UNITED STATES PATENT AND TRADEMARK OFFICE
CERTIFICATE OF CORRECTION

PATENT NO. : 7,477,847 B2
APPLICATION NO. : 10/626965
DATED : January 13, 2009
INVENTOR(S) : Hofmeister et al.

FIG. 3B

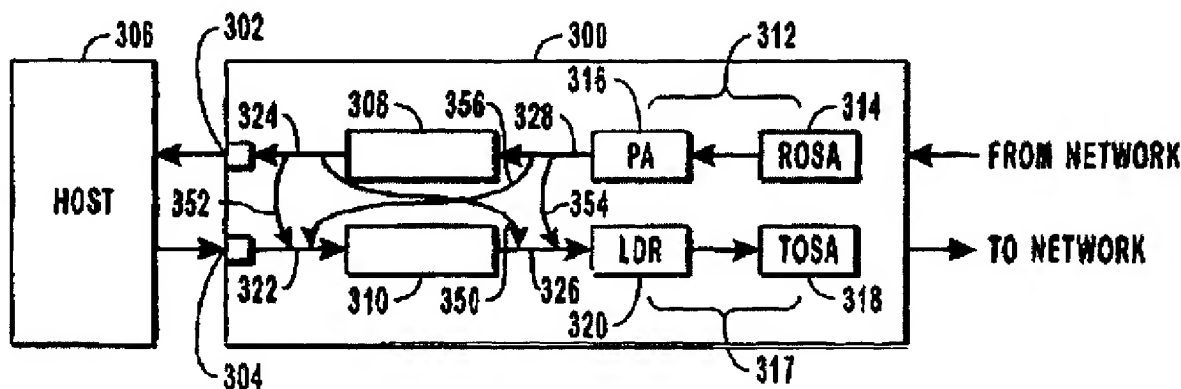
Sheet 2, replace Figure 3B with the figure depicted below, wherein the second instance of "322" has been changed to --326--
